PLANNING DIVISION MASTER APPLICATION FORM

| Project Address: 141 South Lake Avenue | | | |
|---|---|---|--|
| Project Name: 141 South Lake Avenue | | | |

PREDEVELOPMENT PLAN REVIEW COMMENTS

PLANNING & COMMUNITY DEVELOPMENT DEPARTMENT PLANNING DIVISION

No more than 50% of total floor area

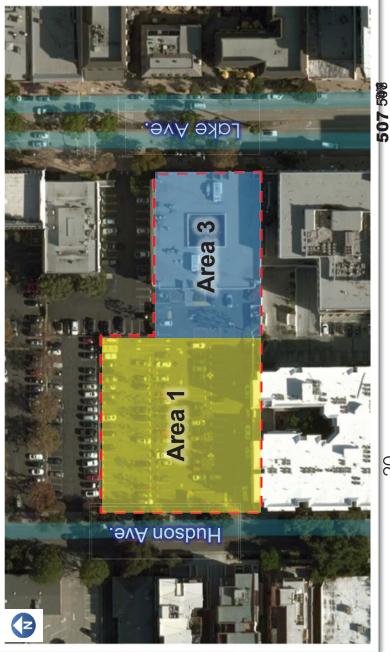
However, the percentage of nonresidential use is not in compliance with the Specific Plan's restrictions on residential use fronting on Lake Avenue (Figure 3-4 Central District Housing/Ground Floor Map). No more than 50 percent of the portion of the building facing Lake Avenue can be comprised of residential use, and 79 percent is currently proposed. Please see the comments regarding restrictions on residential uses below in No. 7 below (Residential Density).
